BUNKER LAKE INDUSTRIAL PARK
BUILDING #5
Ramsey, Minnesota

BLIP V DEVELOPMENT PLANS

CITY OF RAMSEY, MINNESOTA

STORM SEWER PLAN
 CITY OF RAMSEY, MINNESOTA

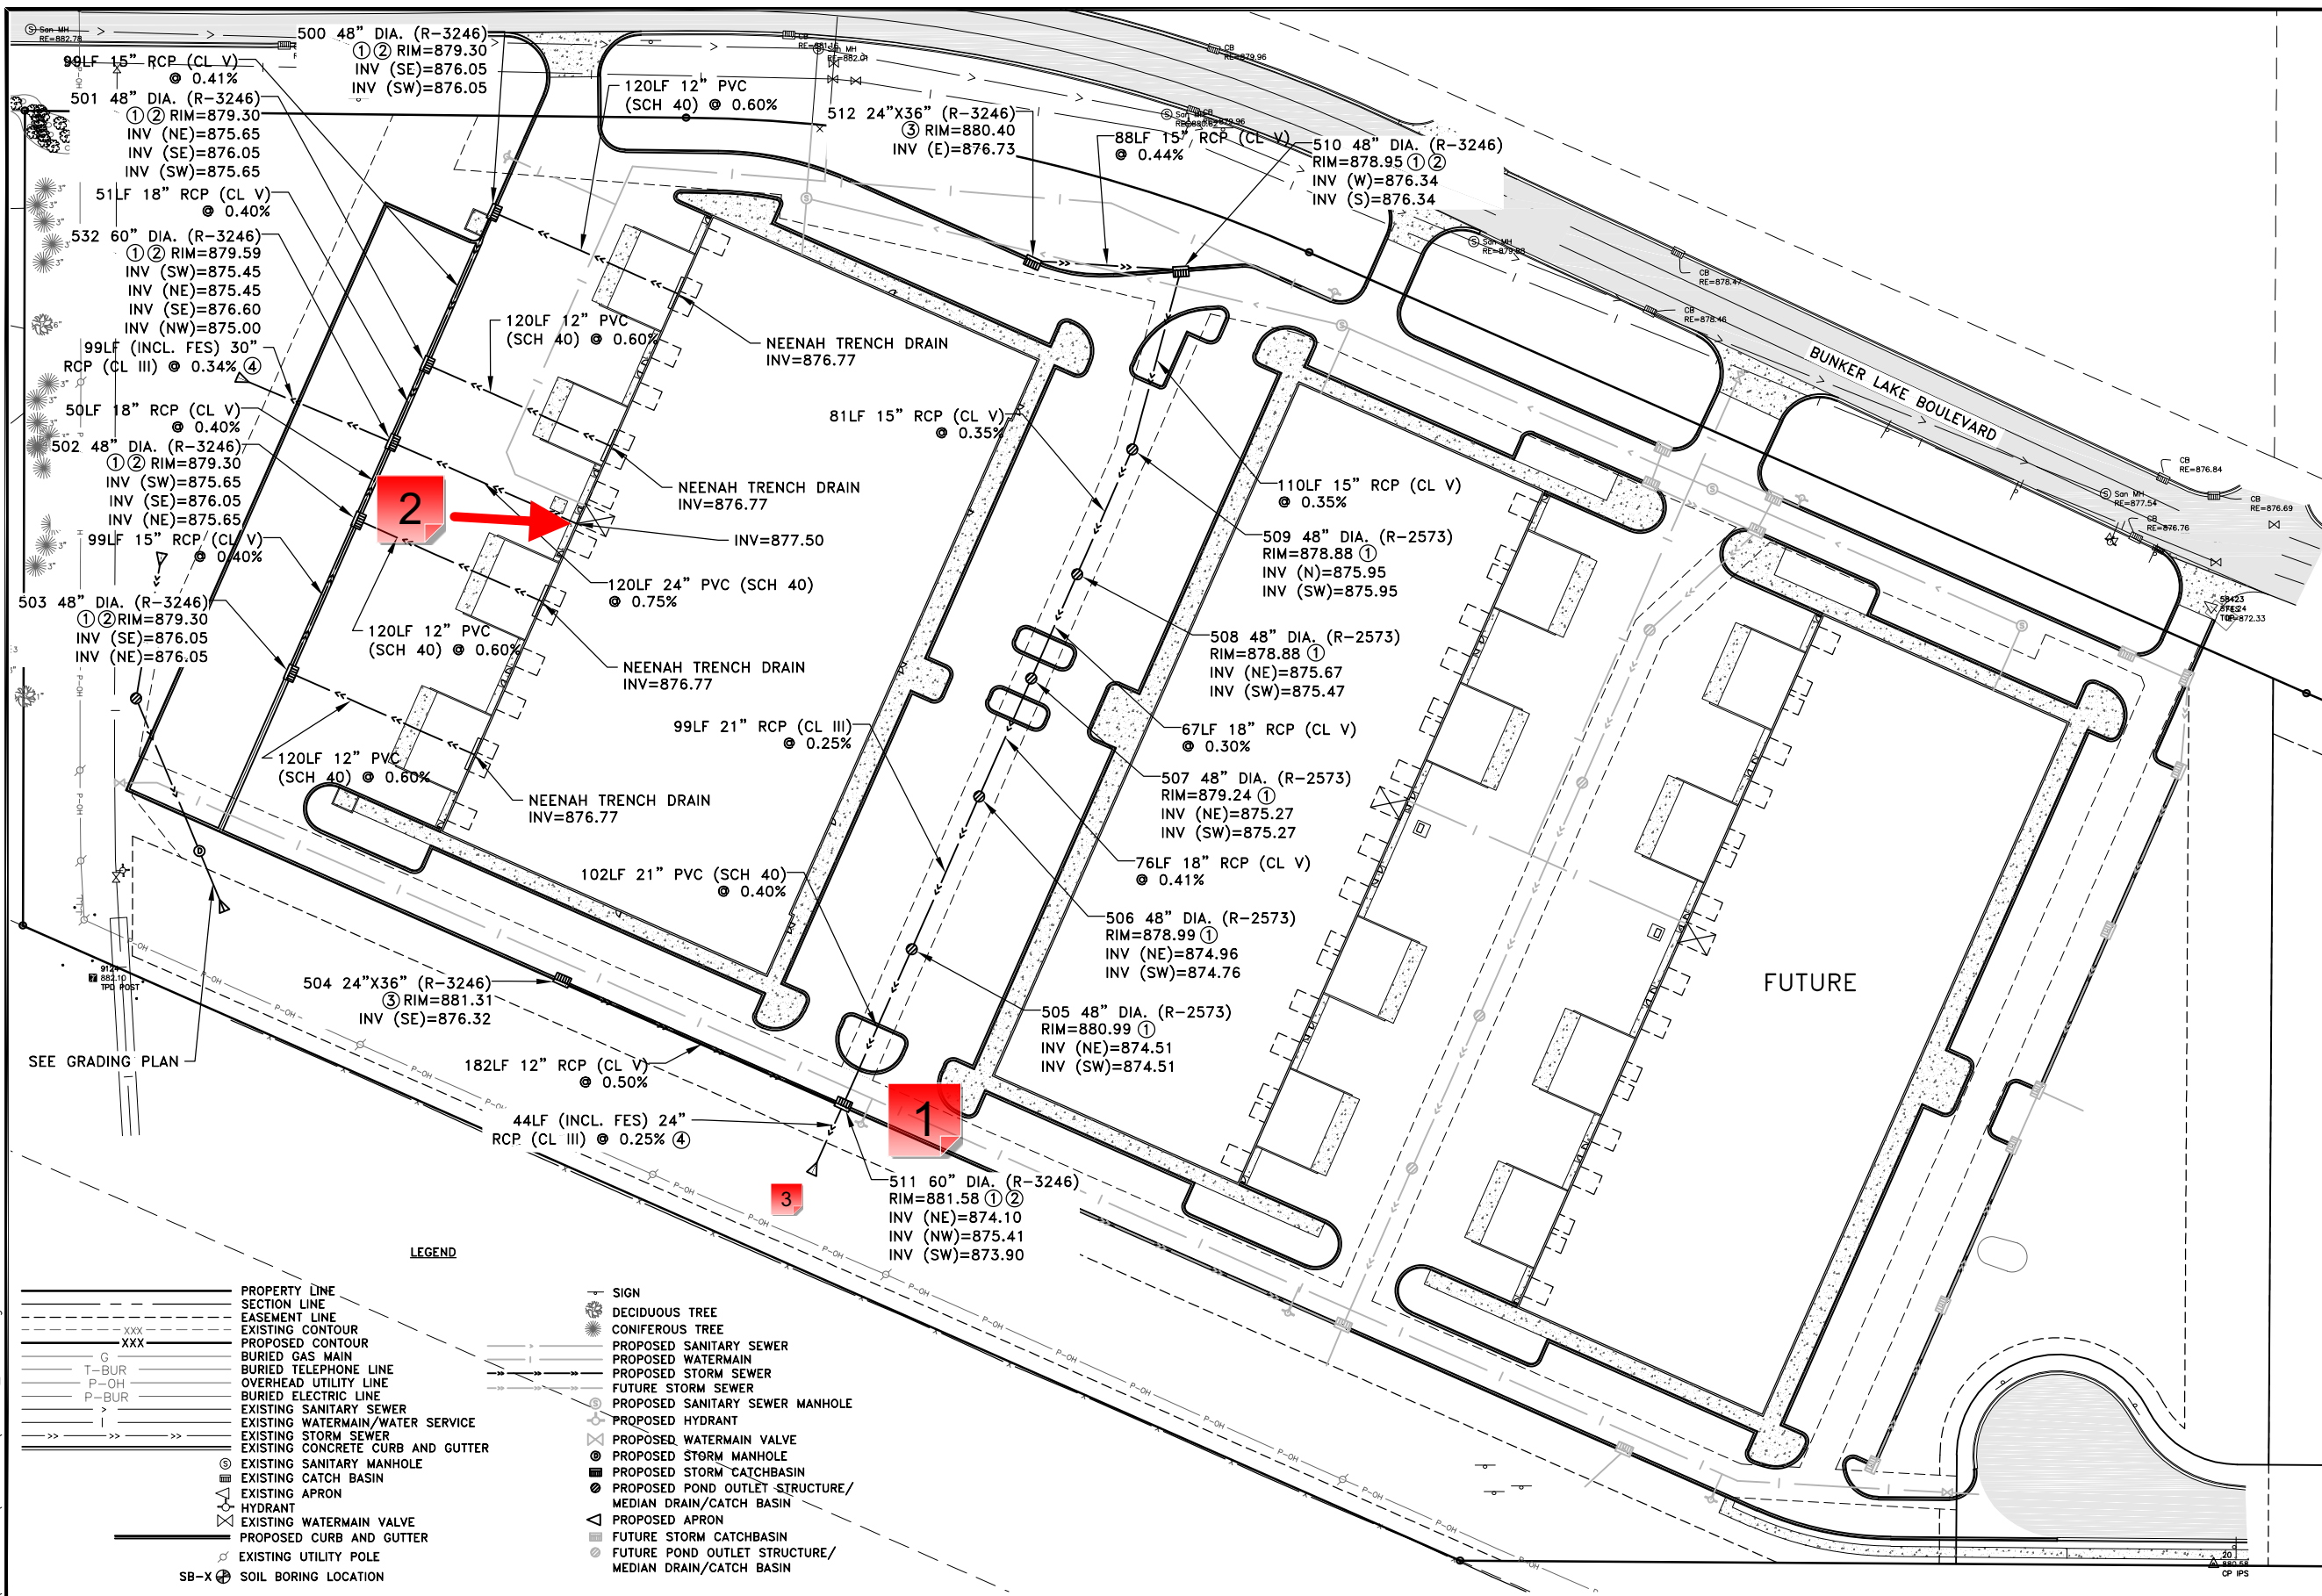
1 - Watermain Storm Crossing

This looks like the storm and water will be very close in elevation. Provide minimum 18" separation and insulate if less than 24"

2 - Drain Elevation

With 883.00' FFE, bottom of footing should be at ~878.75'. It looks like this 24" line may intersect with that footing

3 - FES Inverts

Call out inverts of aprons.

WATERMAIN AND SANITARY SEWER PLAN

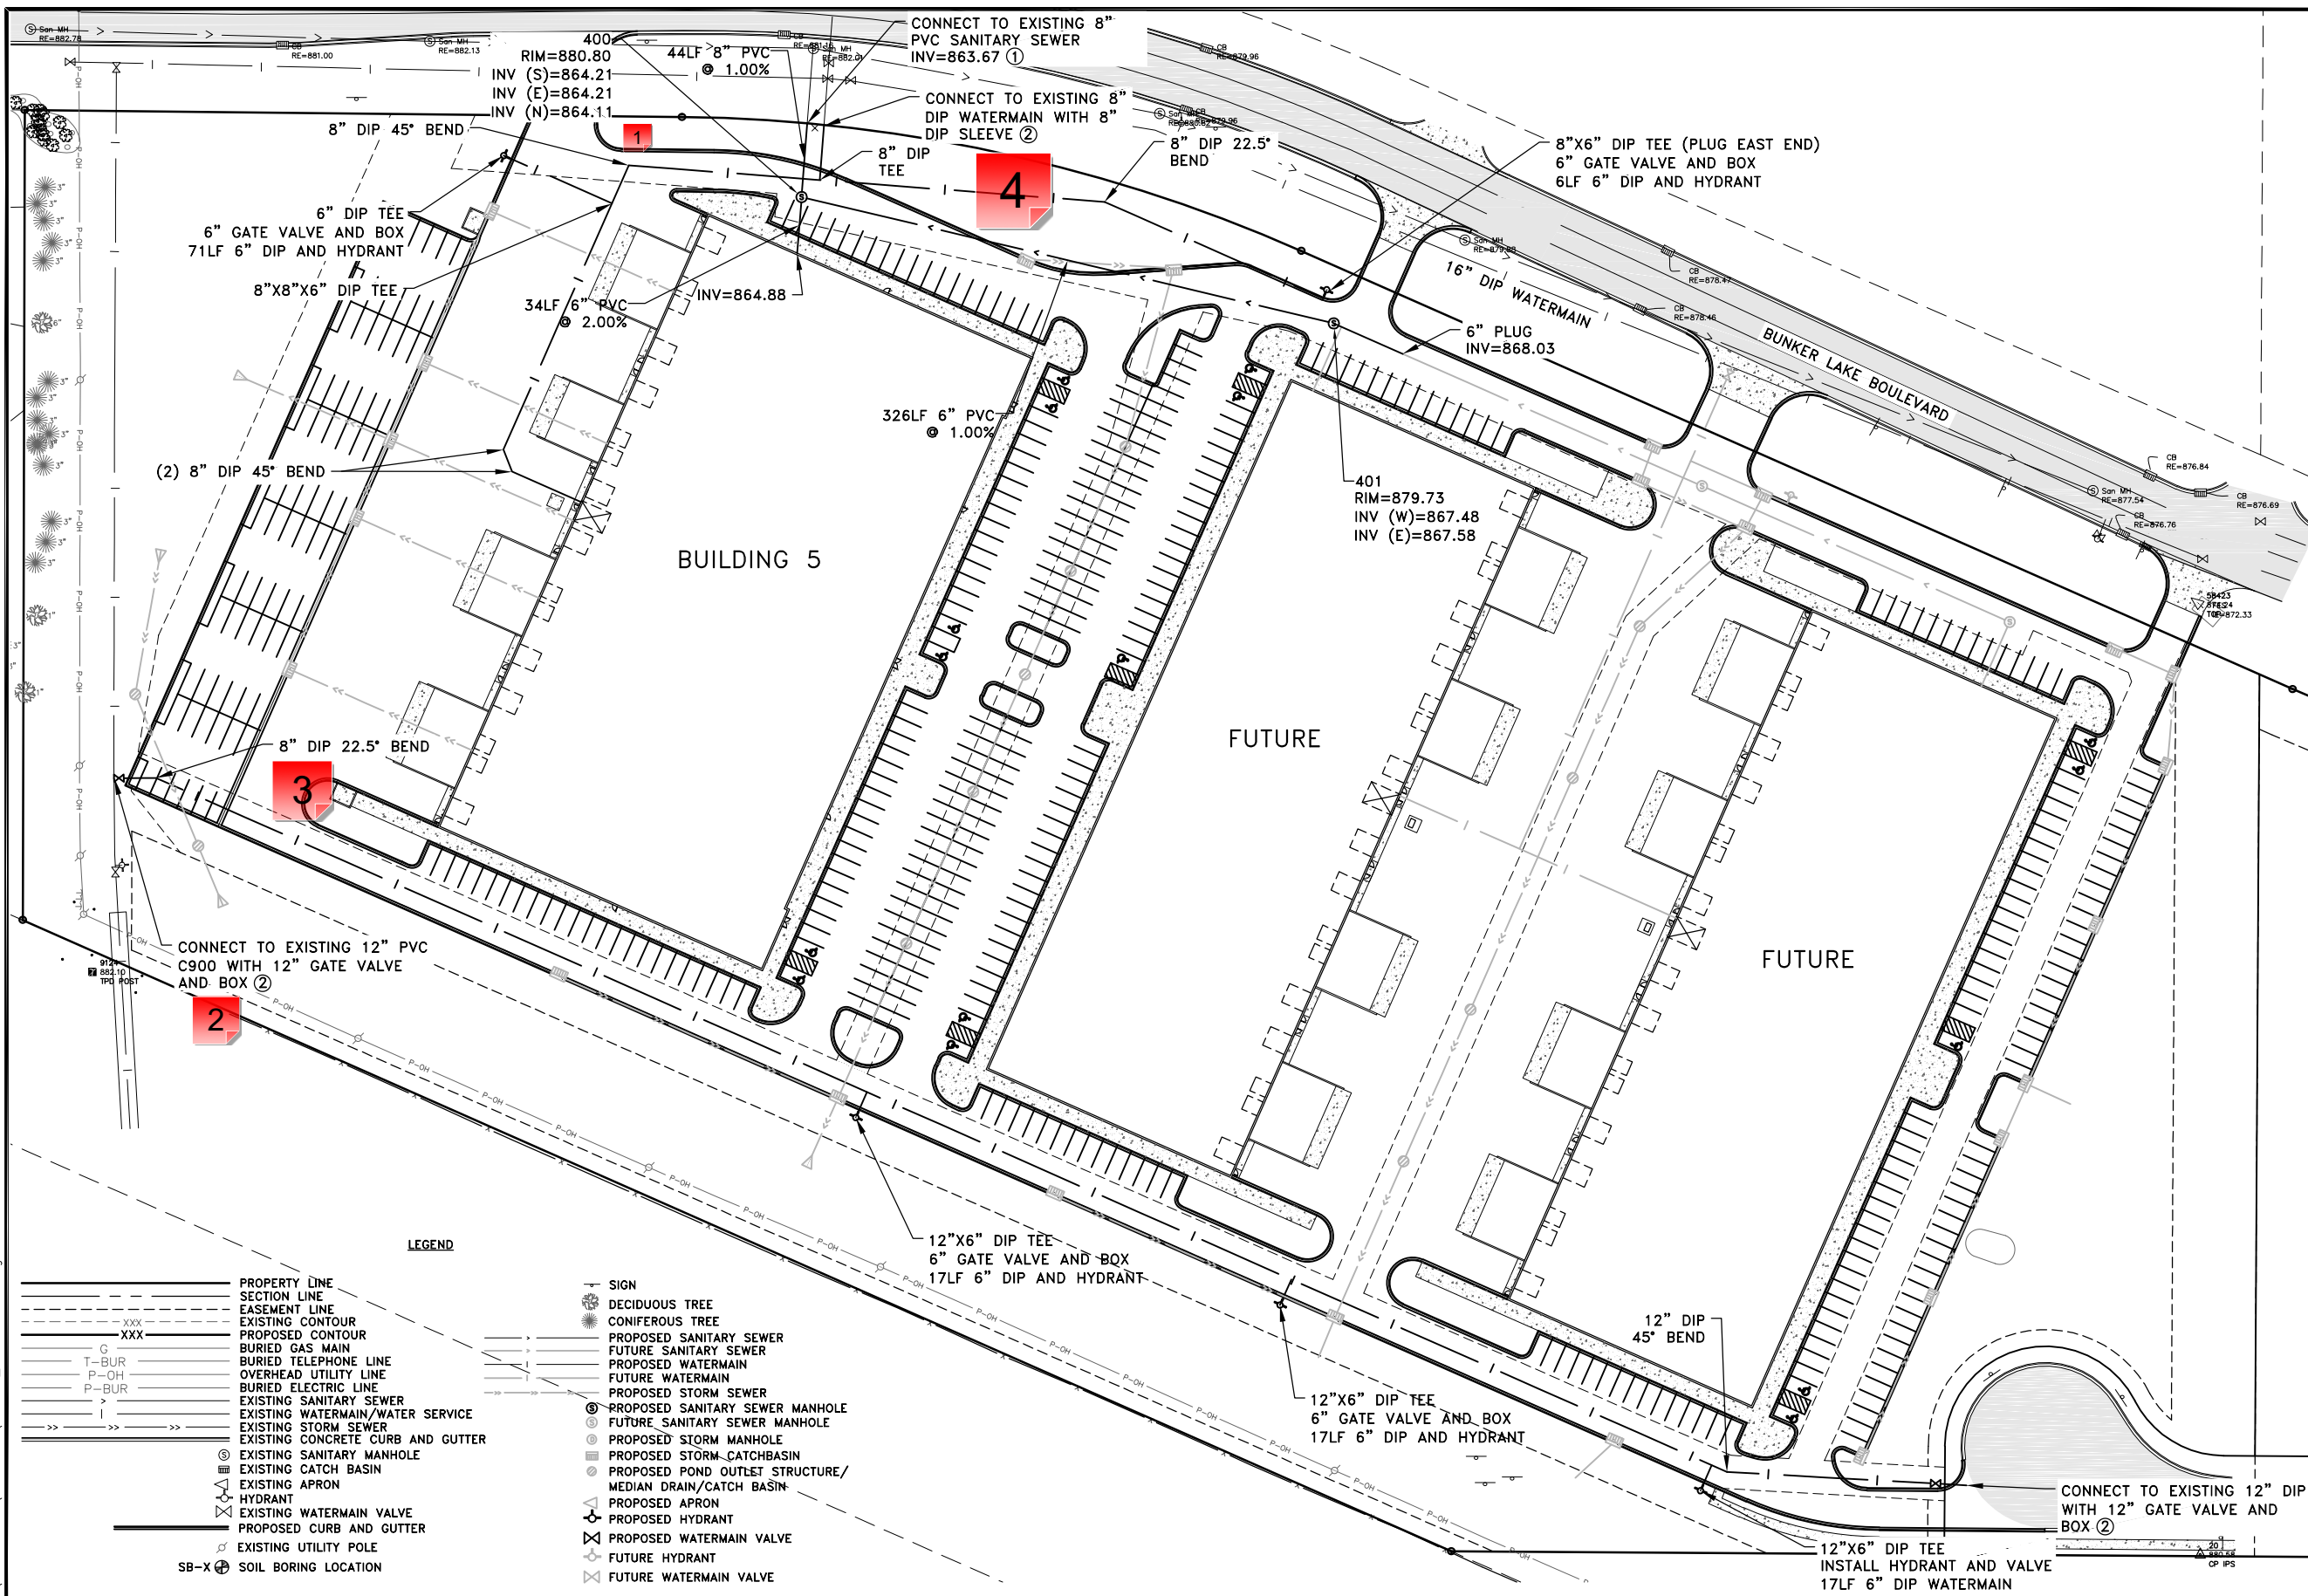
1 - 8" DIP 45 Deg Bend

This looks like much more than a 45 Deg angle, is an additional bend required?

2 - Wet Tap

It looks like this would actually be a 12"x12" wet tap with 12" GV and box correct?

3 - 8" DIP 22.5 Deg Bend

Looks like this should be a 12" bend

4 - Connect to existing WM

No sleeve should be required to connect to existing WM. Avoid sleeves wherever possible.
